RE: DRAINAGE PLAN FOR ADDITION TO AMERICAN BEST WESTERN MOTEL
(L-22/D22) RECEIVED MARCH 26, 1986

REF: REVISED DRAINAGE PLAN FOR ADDITION TO AMERICAN BEST WESTERN MOTEL
DRAINAGE FILE L22/D22

RE: DRAINAGE PLAN FOR ADDITION TO AMERICAN BEST WESTERN MOTEL
(L22/D22) RECEIVED MARCH 14, 1986

GRADING AND DRAINAGE REPORT

SUBAREAS
FOR SWALE
CALCULATIONS

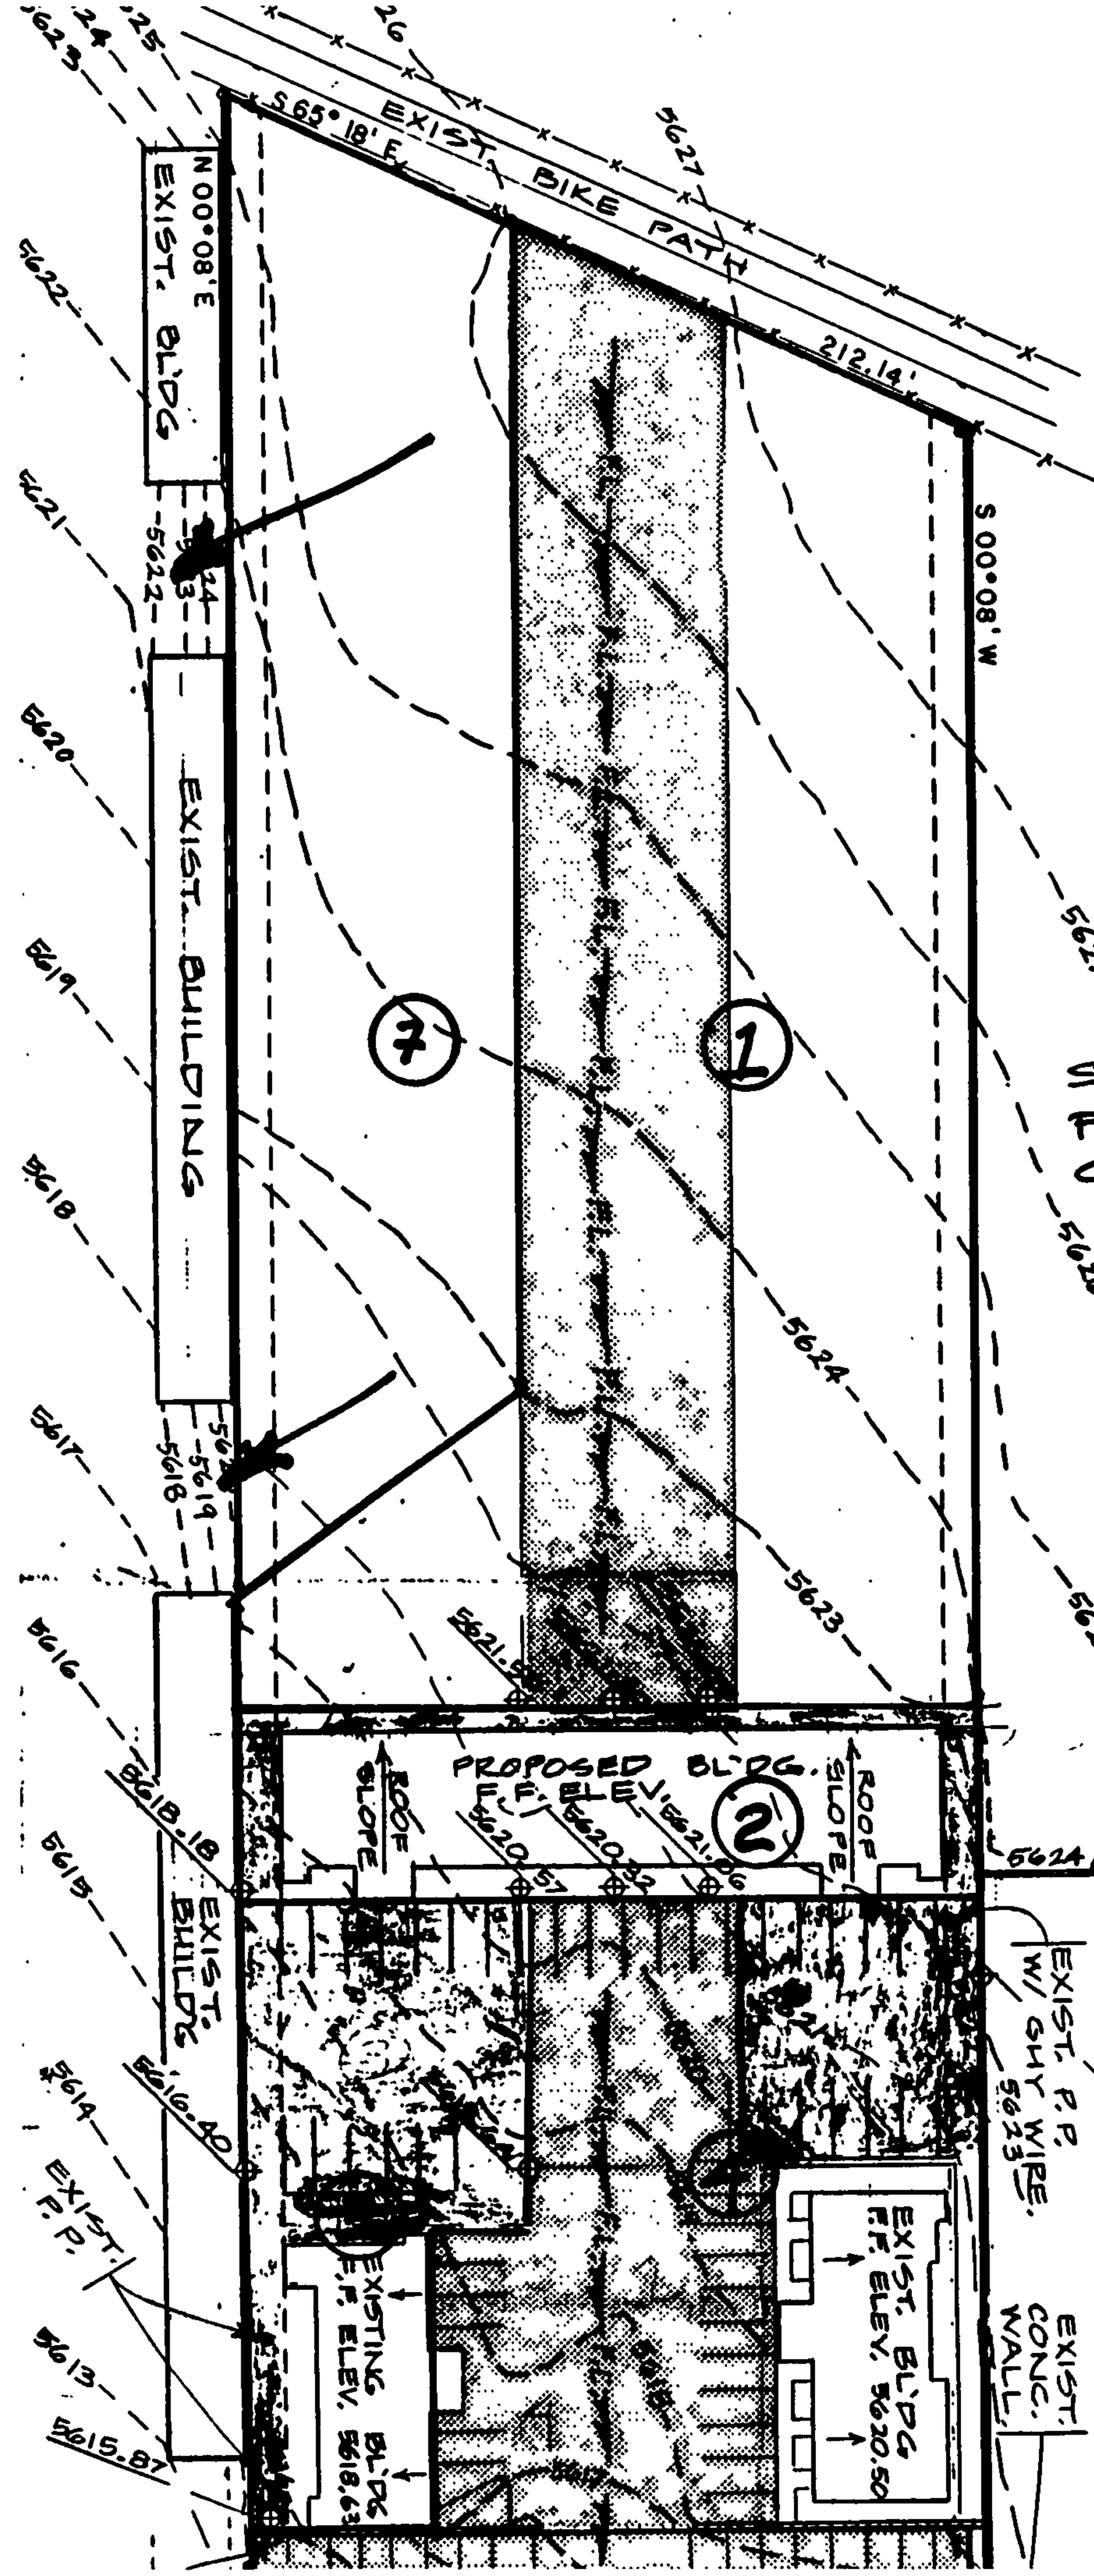
1. New information sheet with resubmittal designation.
2. Please use new criteria found in the notice of Emergency Rule signed into effect by the Mayor on 1/14/86 to compute the "C" values.
3. Notation on Section 4/C1 "Top 1'-0" may remain", please clarify.
4. Please clarify on legend which is existing asphalt and proposed.
5. Note identifying that if land sale takes place, replat will be required to create new lot lines.
6. Description of T.B.M. (rebar, pipe, curb notch, etc?).

Your letter of March 20 (copy enclosed) expressed several concerns regarding the grading and drainage plan for the American Best Western Motel Addition. Primarily these were matters of clarification and I have amended the plans accordingly.

As demonstrated in the original submittal there is only a small change in the amount and rate of runoff caused by this addition. Thus, per our telephone conversation of 3/25/86, I am enclosing a table and calculations showing that the "C" values (and thus the runoff rate) used in the original submittal correspond well to those obtained by the newly prescribed method. For the site as a whole, the new "C"'s are about 2 % lower than the old. The only instance where the new value was higher was for undeveloped (offsite) / flow, 0.40 compared to 0.34. [As you are probably aware, Carlos, compared to values reported in the literature for undeveloped conditions on soils with good infiltration (SCS Hydrologic Group B) on mild slopes, 0.40 is a very high value.]
